## Product Change Notice: 758

Reference ECN #: 43018

### Coilcraft Design Change

| <b>Coilcraft Part #:</b><br>XFL2005 Series parts | <b>Customer:</b><br>All | <b>Customer Part #:</b><br>Various |

Packaging Orientation;

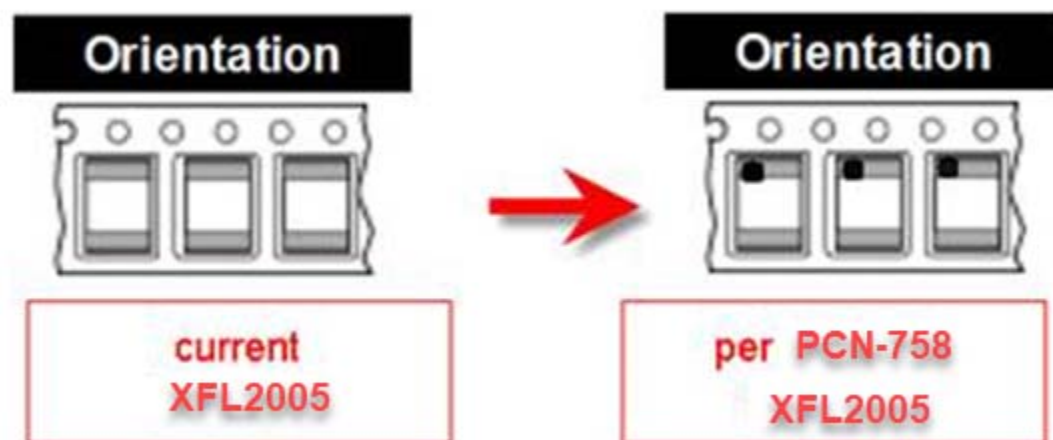
Additional marking of a white dot on top of the part to indicate the inside lead.
